Fabius family

**Anesthesia workstation
Software 3.n**

Supplement to the instructions for use

Device	Part number	Edition
Fabius Tiro	9038686	Up to 7. Edition
Fabius GS <i>premium</i>	9038923	Up to 7. Edition
Fabius MRI	9039036	Up to 8. Edition
Fabius <i>plus</i>	9039054	Up to 4. Edition
Fabius <i>plus</i> XL	9052882	Up to 1. Edition

Accessing the alarm log

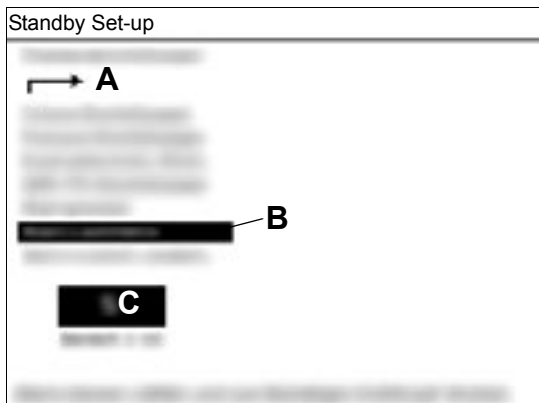
The following text is added:

The alarm log lists all alarm messages, together with their respective date and time.

A maximum of 100 entries is saved.

The oldest entries will be overwritten if the storage capacity is reached.

Minimum alarm volume

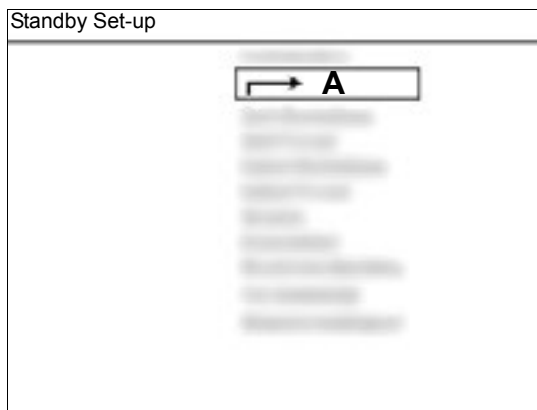
The label for the alarm volume setting has been changed to **Minimum Alarm Volume**.

- 1 Select **Minimum Alarm Volume** (B) and confirm.

The current minimum alarm volume (C) is displayed on the screen.

- 2 Set the new minimum alarm volume to a value between 1 (minimum) and 10 (maximum) and confirm.

Range: ≥ 45 dB(A) to ≤ 85 dB(A)

Accessing the alarm volume

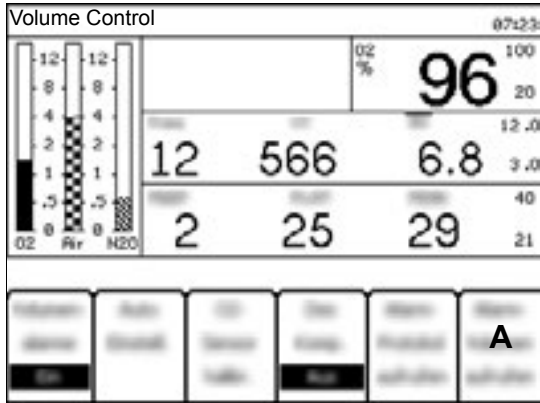
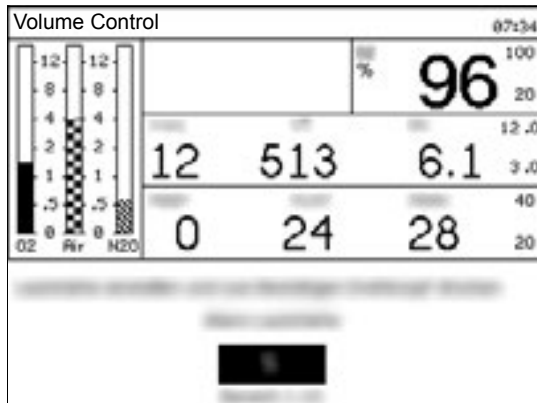
The following warning and text are added to the chapter:

- 1 Press the **Access Alarm Volume** softkey (A).

- 2 Set the new alarm volume to a value between 1 (minimum) and 10 (maximum) and confirm.

The lower value is limited to the setting in the standby configuration.
